WOODROW WILSON BRIDGE REPLACEMENT
REVISED DESIGN PLANS FOR THE URBAN DECK
AT WASHINGTON STREET (GEORGE WASHINGTON MEMORIAL PARKWAY)
City of Alexandria, Virginia

Report to the Federal Highway Administration and the National Park Service

November 1, 2001

DETAIL VIEW OF URBAN DECK

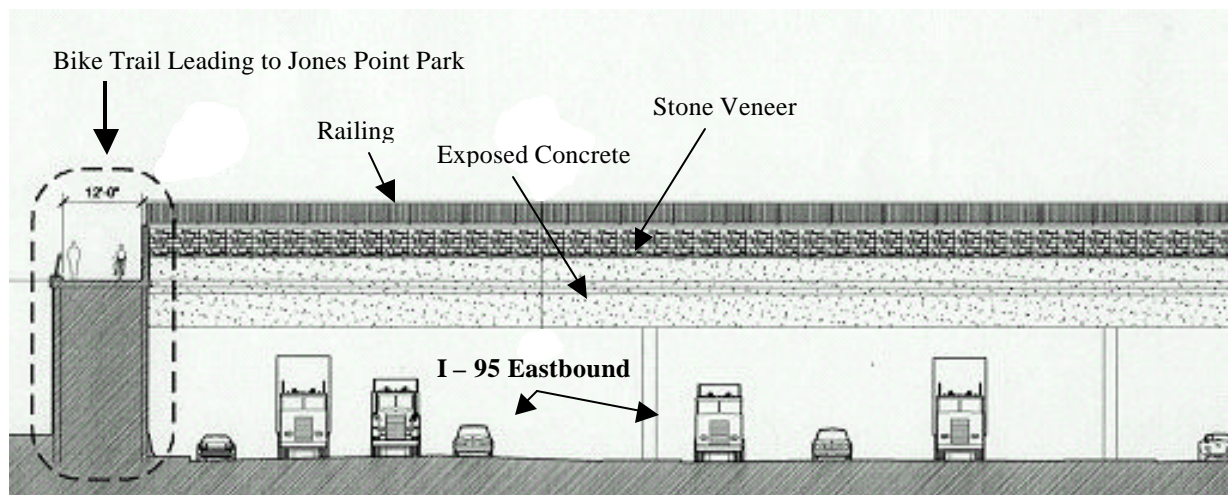
The progress made in the design of the this ancillary component of the Wilson Bridge project, since the Commission's March 2001 review, is encouraging. The detailed design plans successfully meet the public and local jurisdictional concerns involving proportions, location and the impacts to the Parkway environs. Moreover, the desire to improve the availability and access of additional amenities for public enjoyment, in conjunction with the more pragmatic requirements of road improvement, has resulted in an acceptable streetscape and open space amenity that is appropriate. FHWA's concern for developing a harmonious design that integrates physical details of the parkway elements into the overall deck design is apparent. The coordination of the urban deck design is fully reflected in the final location of all traffic noise barriers situated along the I-95 urban deck corridor, and also in how the deck relates to the corridor and features of George Washington Memorial Parkway. As indicated in the final plans, the deck exhibits no signage above the mainline travel lanes of I-95.

Staff believes the final design of the urban deck has addressed all issues the Commission raised about visual graphics and signage that is to be utilized at this area of the bridge project. Moreover, the design has maintained a prominent level of physical organization and design sensitivity to the deck's detailing, location, and materials, that without the careful attention demonstrated, would have undoubtedly degraded an important community amenity associated with this significant regional transportation project.

SOUTH PORTION OF URBAN DECK SHOWING DETAIL OF RAILING, STONE VENEER, AND EXPOSED CONCRETE FINISH

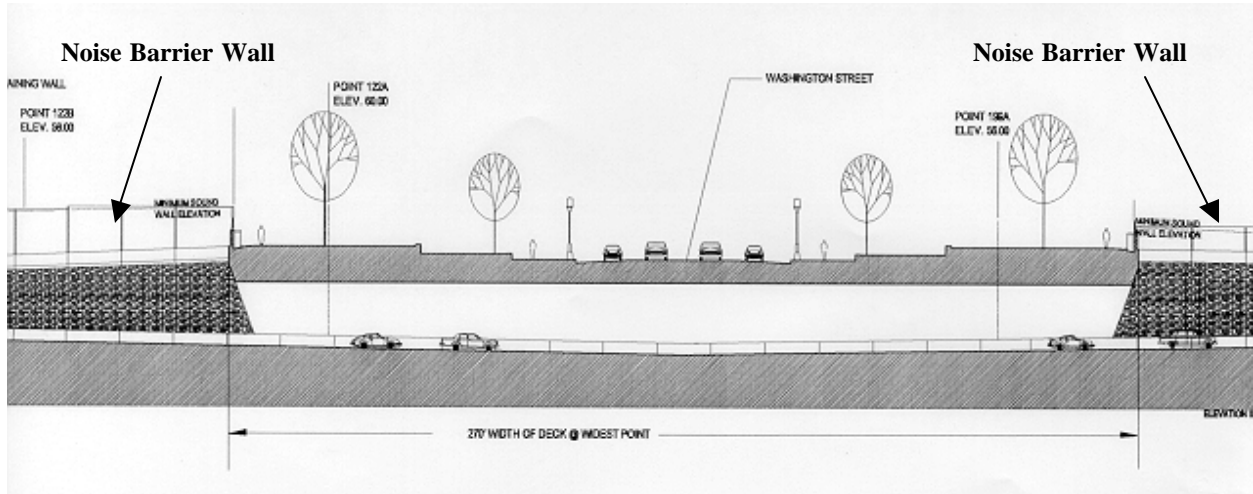
In early September through October 2001, FHWA met with NCPC staff to review the Commission's request for information on the final design plans for the urban deck wall surfaces and the traffic noise barriers that were to occur in the area. At that time, various discussions also transpired about potential railing materials, paved surfaces, signage configurations, and design characteristics that would be finalized.
